Access Compliance Report Public Rights-of-Way (Curb Ramps)

Intersection ID: 10033270 Main Street: OAKDALE_GREEN_DR Cross Street: N/A Location: NW

ADA ID: A10D83F755AC Ramp Type: Perp Initial Pass/Fail: Fail Overall Compliance: No Severity Score: 25

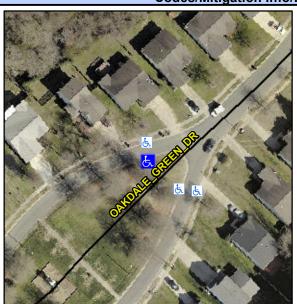
Compliance Description [Data	Comp	liance Description	Data
N/A	Ramp Length (in)	208.0	Yes	Ramp Slope (%)	13.2
Yes	Ramp Width (in)	60.0	Yes	Ramp XSlope (%)	0.6
N/A	Flare Type LT	N/A	N/A	Flare Type RT	N/A
N/A	Flare Slope LT (%)	N/A	N/A	Flare Slope RT (%)	N/A
N/A	Flare Traversable LT?	N/A	N/A	Flare Traversable RT?	N/A
N/A	Landing Length (in)	N/A	N/A	DWS Provided?	N/A
N/A	Landing Width (in)	N/A	N/A	DWS Contrast?	N/A
N/A	Landing Slope (%)	N/A	N/A	DWS Length (in)	N/A
N/A	Landing X Slope (%)	N/A	N/A	DWS Full Width?	N/A
N/A	Landing Curb? (Y/N)	N/A	N/A	DWS Offset (in)	N/A
N/A	Shared Landing?	N/A			
N/A	Gutter Ponding?	N/A	N/A	Gutter Slope (%)	N/A
N/A	Gutter Lip Ht (in)	N/A	N/A	Gutter X Slope (%)	N/A
N/A	Painted X Walk1?	No	N/A	Painted X Walk2?	N/A
	X Walk 1 Direction	To NE		X Walk 2 Direction	N/A
N/A	X Walk 1 Width (in)	N/A	N/A	X Walk 2 Width (in)	N/A
	X Walk 1 Slope (%)	1.2		X Walk 2 Slope (%)	N/A
	X Walk 1 X Slope (%)	2.4		X Walk 2 X Slope (%)	N/A

Remove & Replace Entire Ramp.
